Access Compliance Report

Public Rights-of-Way

(Curb Ramps)

Intersection ID: 49251	Main Street: RIDGE_PATH_LN	Cross Street: PROSPERITY_RIDGE_RD	Location: E
ADA ID: 84B429AD12B5	Ramp Type: Perp	Initial Pass/Fail: Fail	Overall Compliance: No
Severity Score: 8.75			
Codes/Mitigation Info/Possible Solution		Field Measurements/Component Compliance

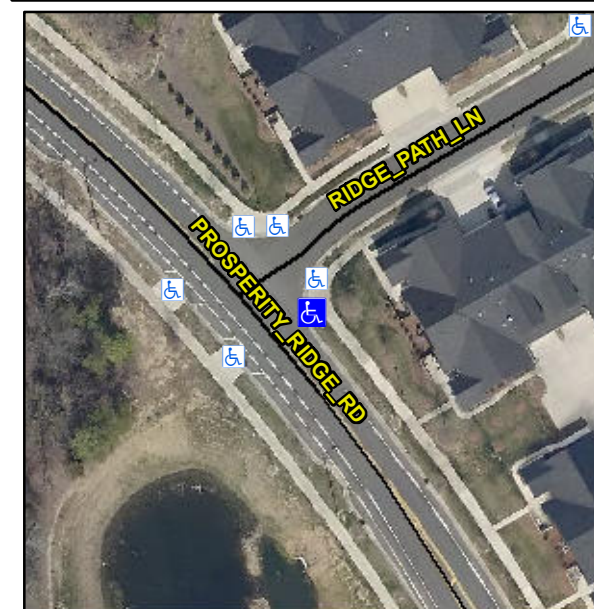
Not Found, R304.5.1

Compliance	Description	Data	Compliance	Description	Data
N/A	Ramp Length (in)	84.5	Yes	Ramp Slope (%)	5.2
No	Ramp Width (in)	47.0	Yes	Ramp XSlope (%)	1.8
N/A	Flare Type LT	N/A	N/A	Flare Type RT	N/A
N/A	Flare Slope LT (%)	N/A	N/A	Flare Slope RT (%)	N/A
N/A	Flare Traversable LT?	N/A	N/A	Flare Traversable RT?	N/A
N/A	Landing Length (in)	N/A	N/A	DWS Provided?	N/A
N/A	Landing Width (in)	N/A	N/A	DWS Contrast?	N/A
N/A	Landing Slope (%)	N/A	N/A	DWS Length (in)	N/A
N/A	Landing X Slope (%)	N/A	N/A	DWS Full Width?	N/A
N/A	Landing Curb? (Y/N)	N/A	N/A	DWS Offset (in)	N/A
N/A	Shared Landing?	N/A			
N/A	Gutter Ponding?	N/A	N/A	Gutter Slope (%)	N/A
N/A	Gutter Lip Ht (in)	N/A	N/A	Gutter X Slope (%)	N/A
N/A	Painted X Walk1?	No	N/A	Painted X Walk2?	N/A
	X Walk 1 Direction	To SW		X Walk 2 Direction	N/A
N/A	X Walk 1 Width (in)	N/A	N/A	X Walk 2 Width (in)	N/A
	X Walk 1 Slope (%)	3.0		X Walk 2 Slope (%)	N/A
	X Walk 1 X Slope (%)	2.0		X Walk 2 X Slope (%)	N/A

Remove & Replace Entire Ramp.
